LCR# 85-07

ATTACHMENT A

MARKED-UP SALEM FSAR SECTION 15.4.8.2
STEAMLINE BREAKS

Containment Temperature Transient
 0.908 FT2 Split Break
 70% Power Minimum Safeguards Westinghouse Mode 1

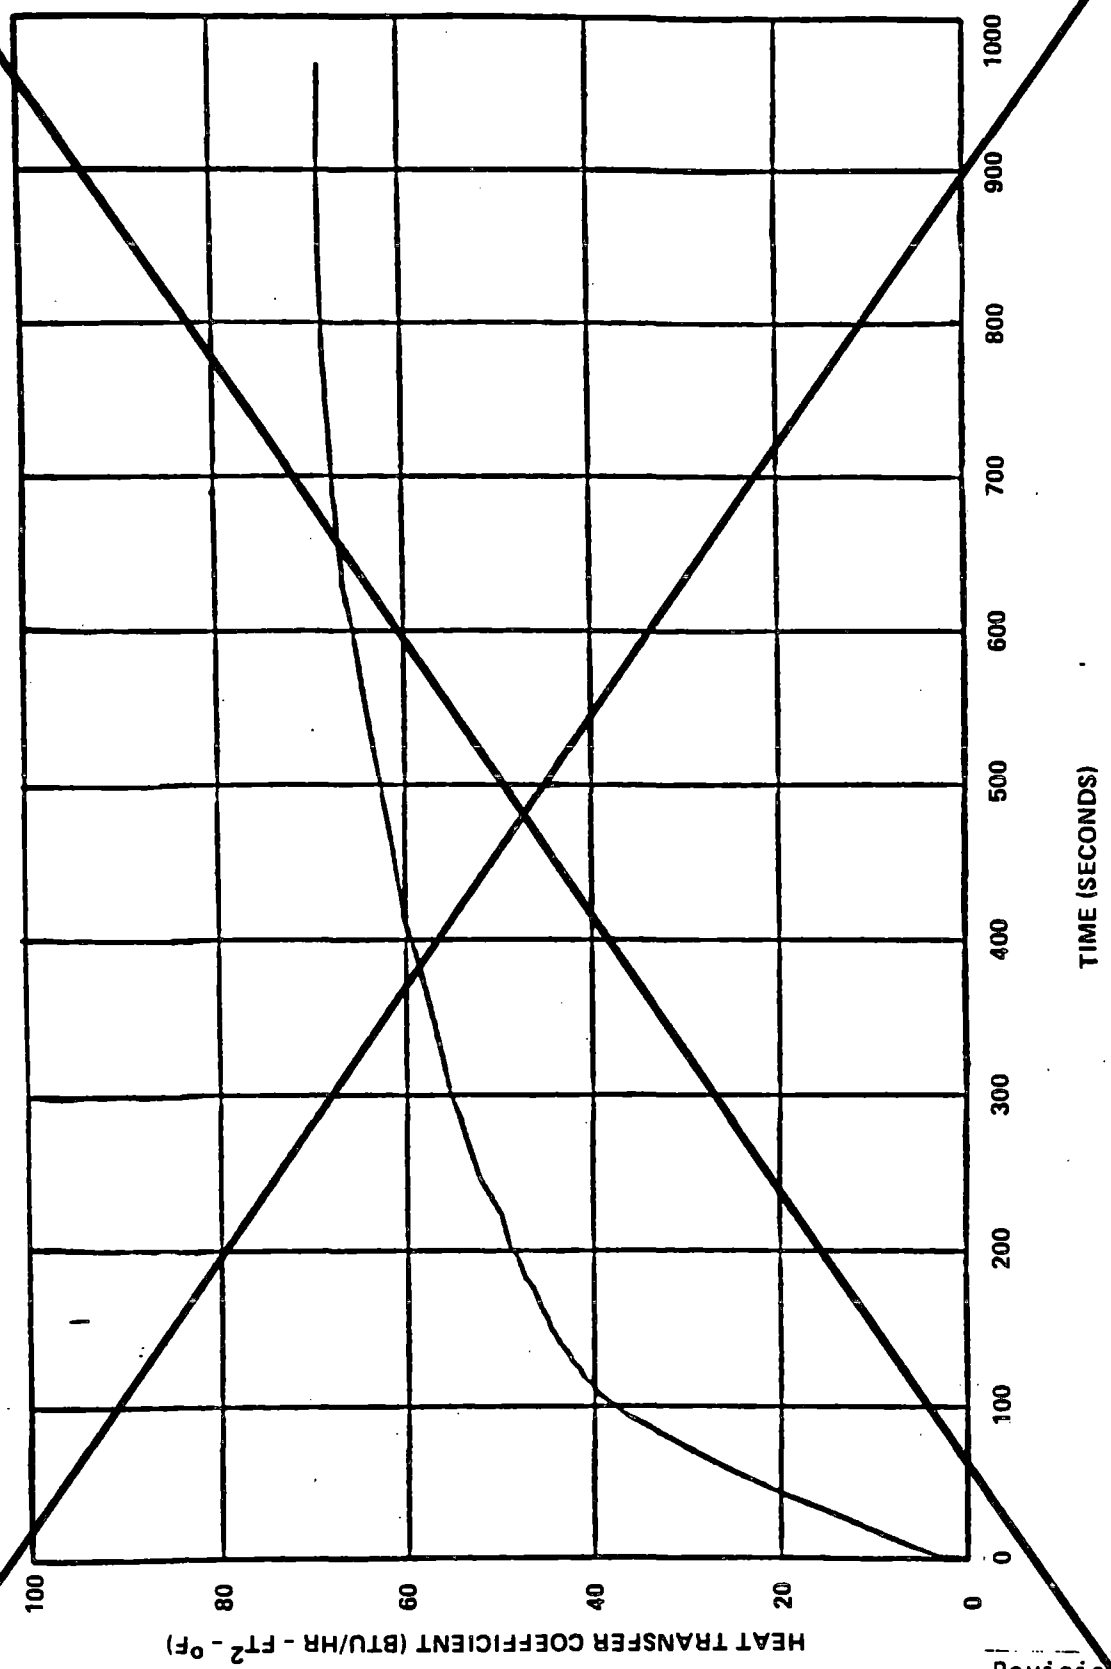
Updated FSAR **DELETE**

Containment Pressure Transient for 0.908 FT2
 Split Break at 70% Power with
 Minimum Safeguards (NRC Model)

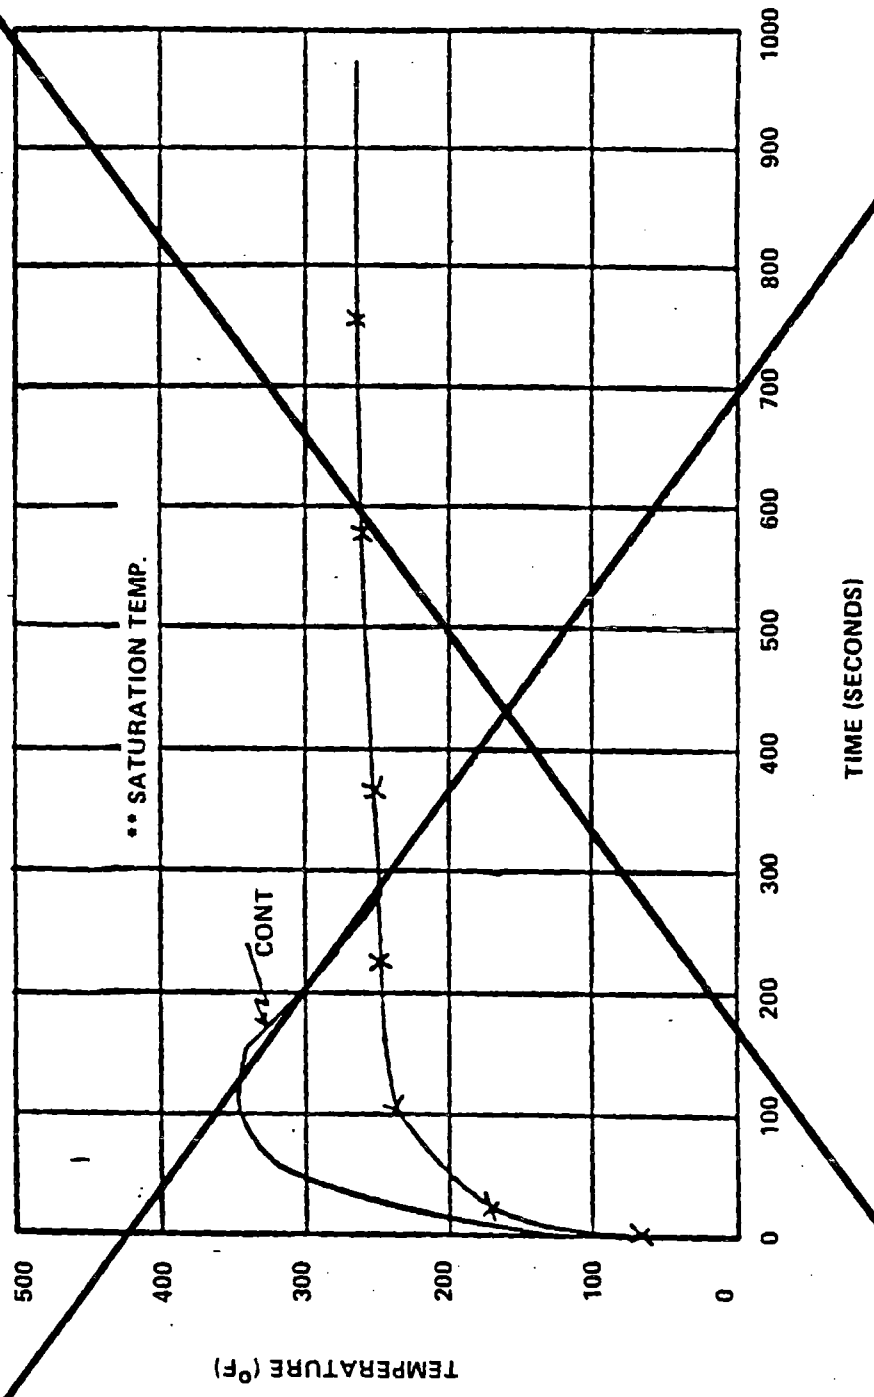
Updated FSAR **DELETE**

PUBLIC SERVICE ELECTRIC AND GAS COMPANY SALEM NUCLEAR GENERATING STATION	Transient Response for a Steam Line Break Equivalent to 228 Lb/Sec at 1015 PSIA with Outside Power Available
	Updated FSAR Figure 15.2-43

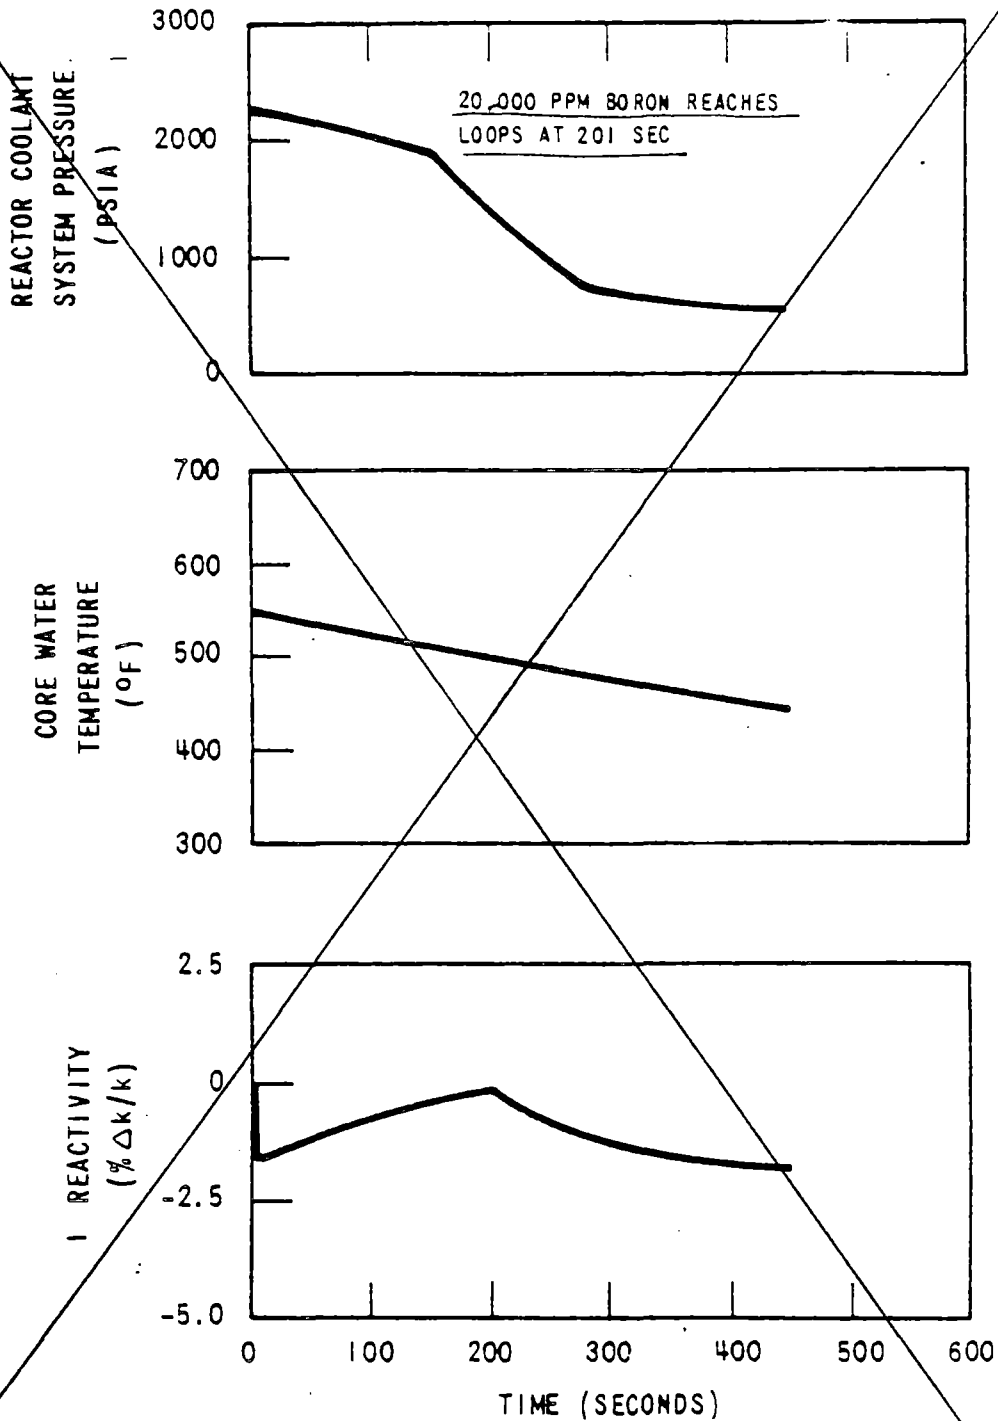
DELETE FIGURE

Figure 15.4-54

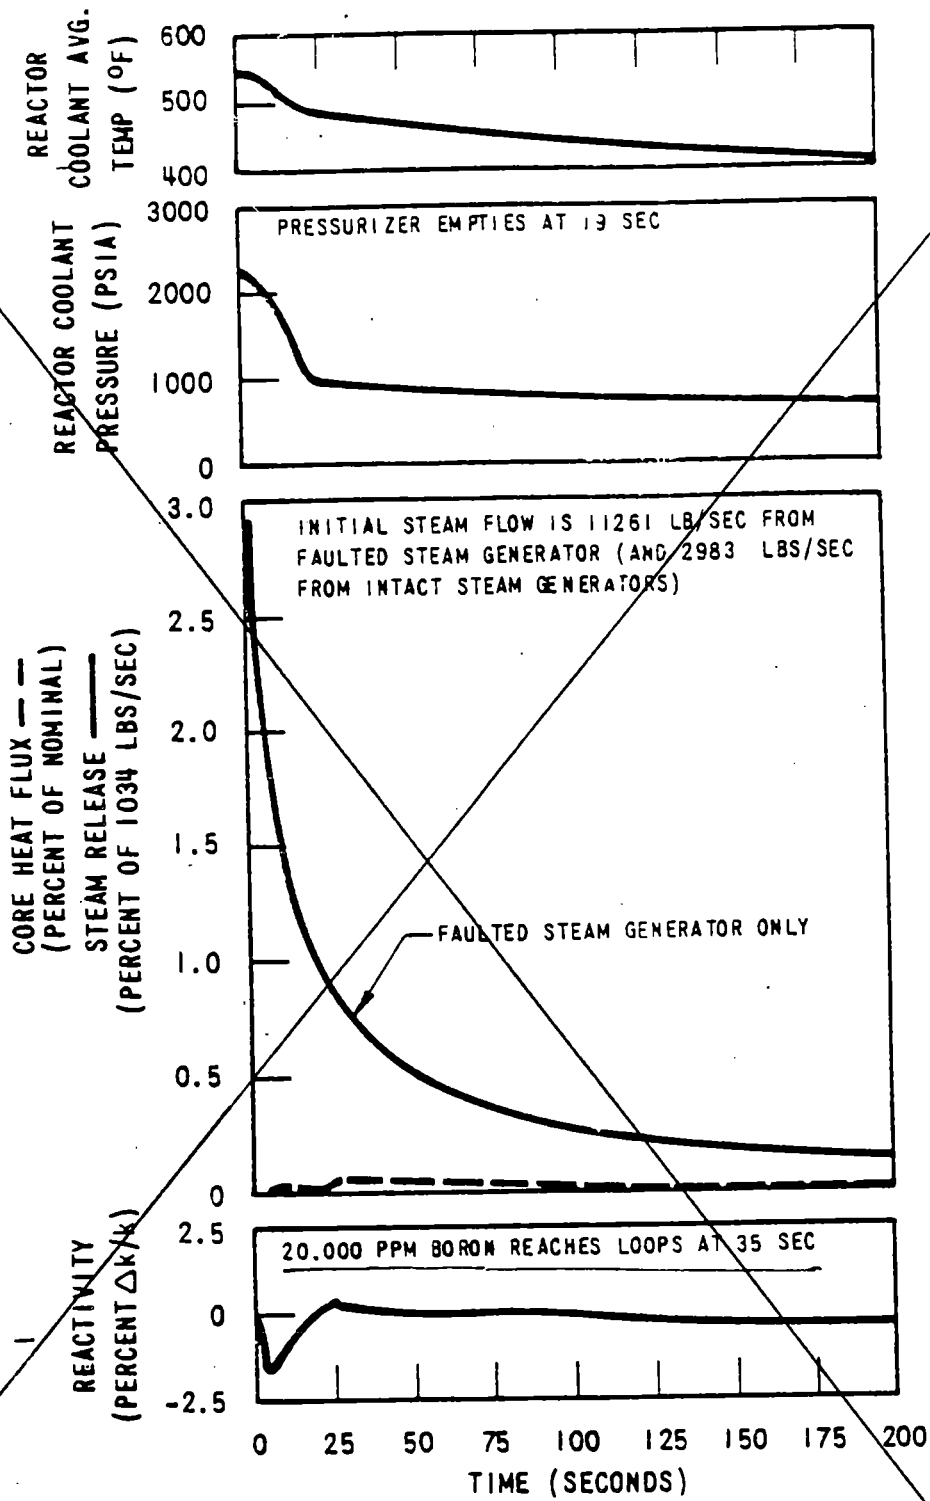
DELETE FIGURE

-Figure 15.4-55-

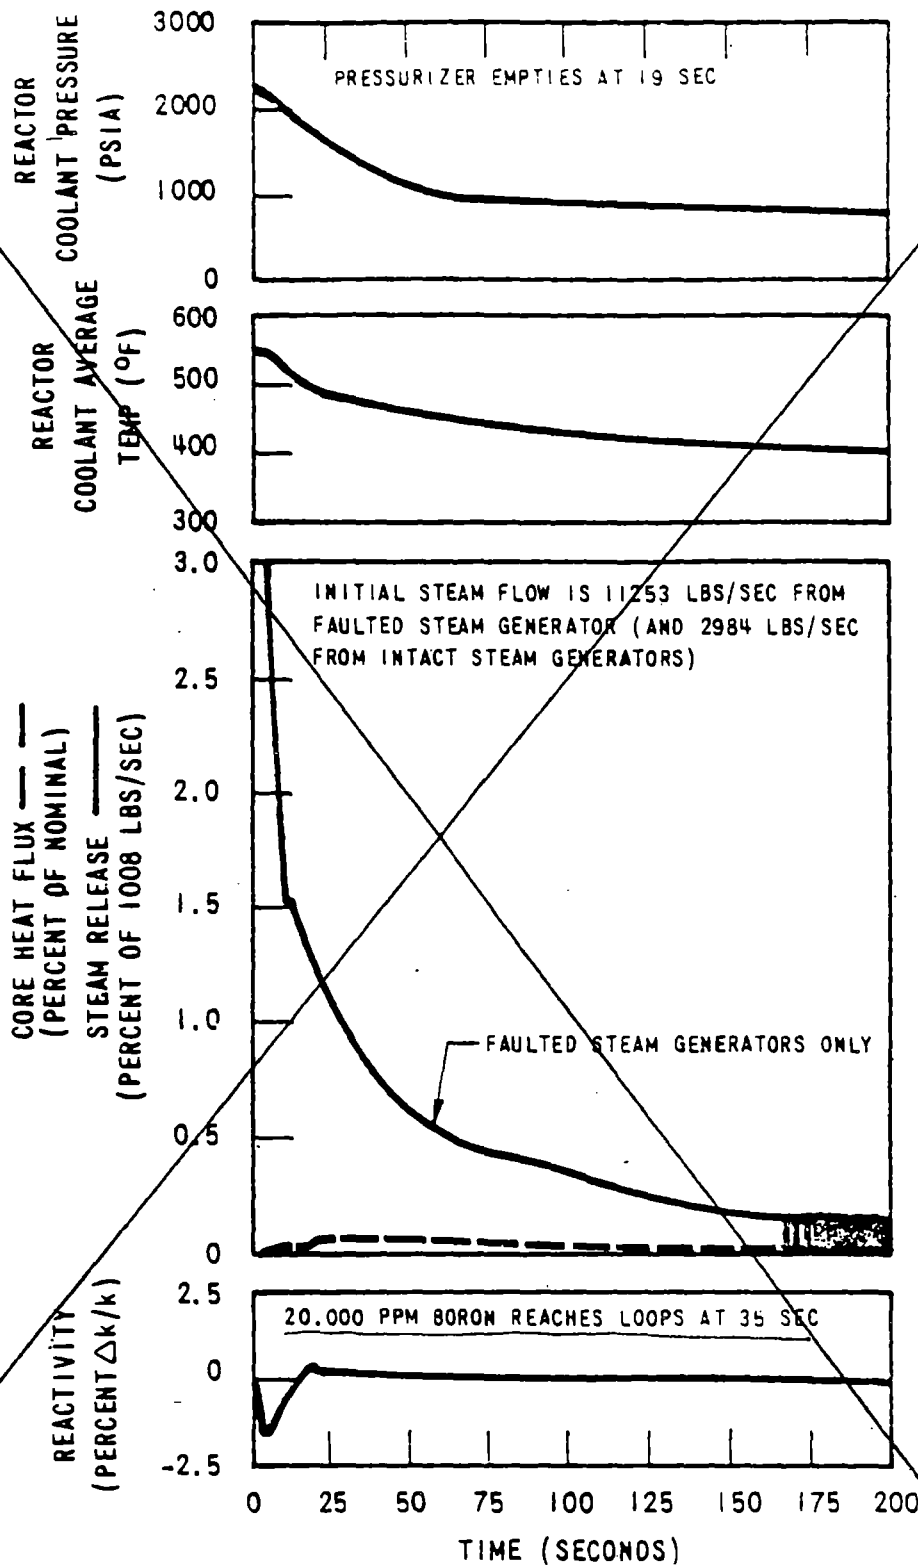
DELETE FIGURE

Figure 15.4.56

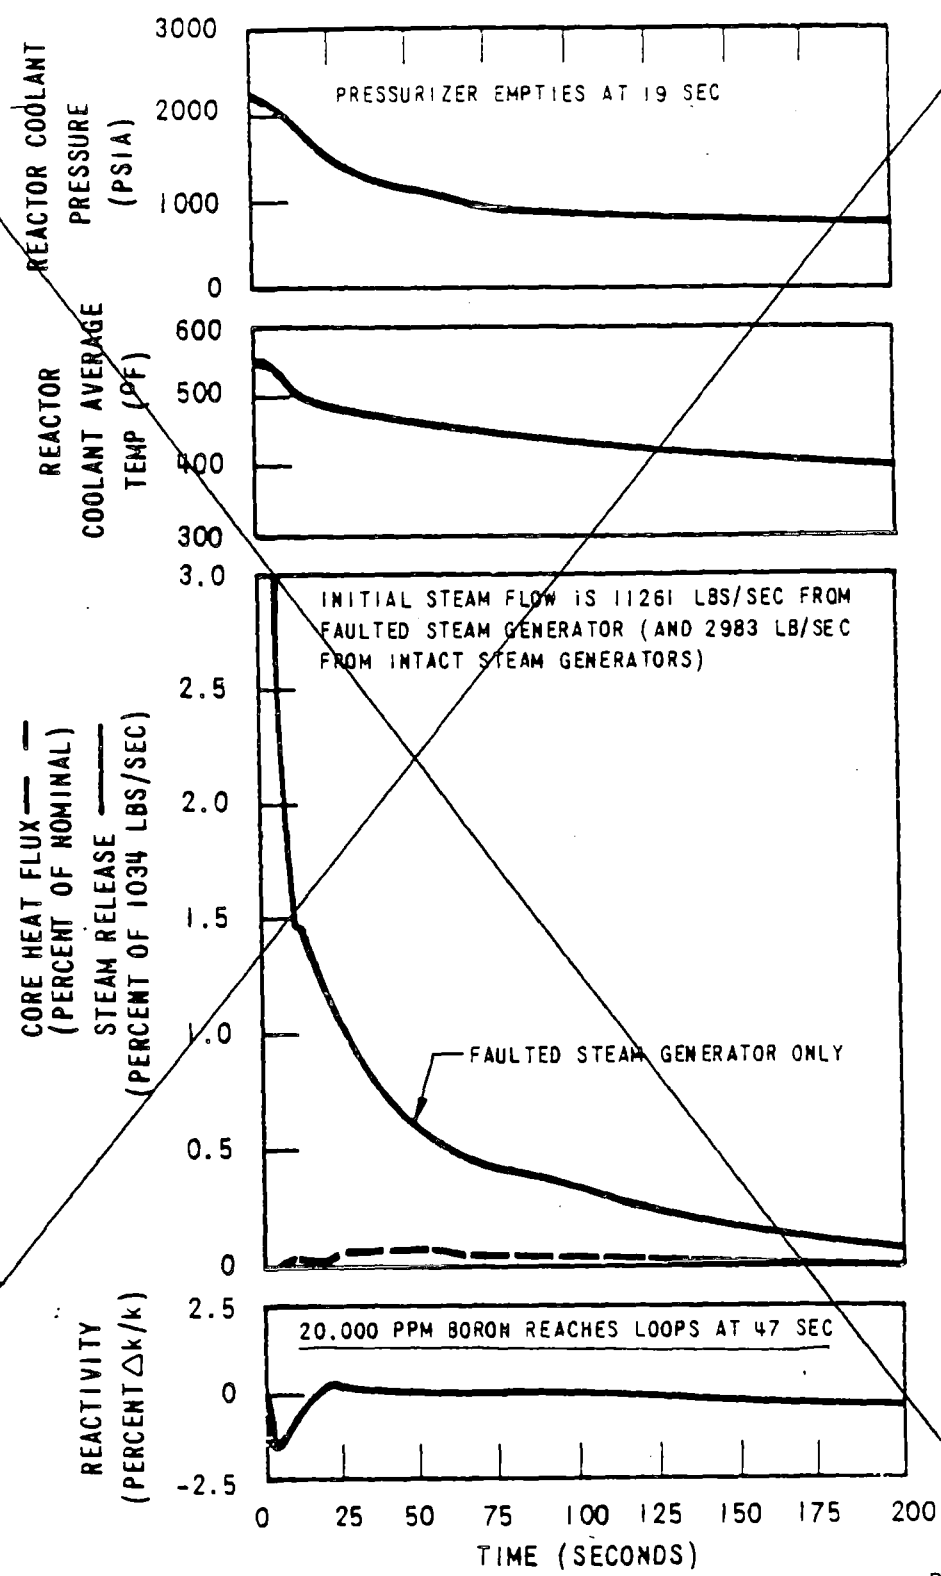
DELETE FIGURE

Figure 15.4.57

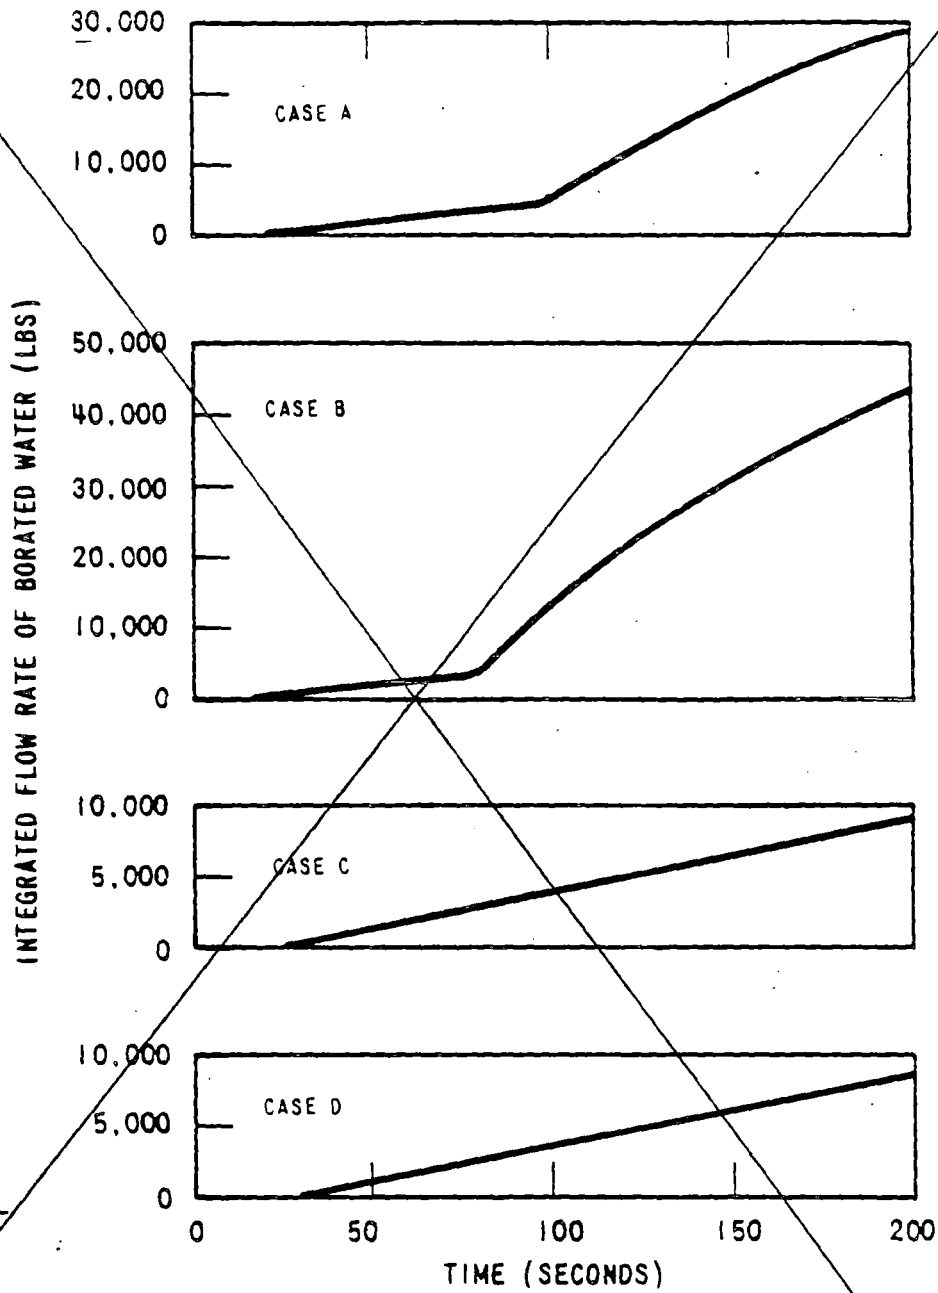
DELETE FIGURE

Figure 15.4-58

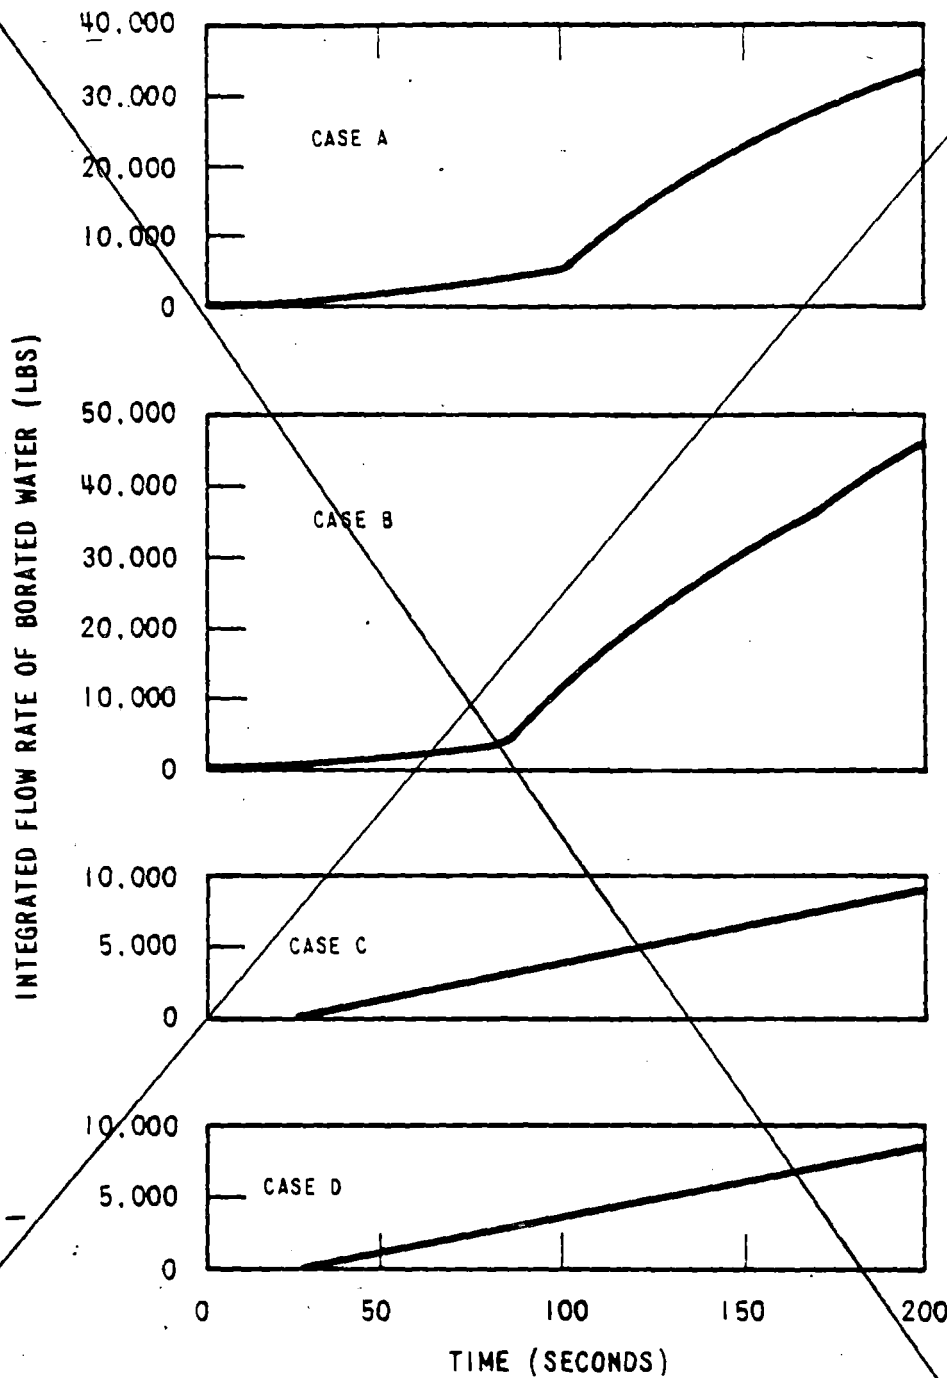
DELETE FIGURE
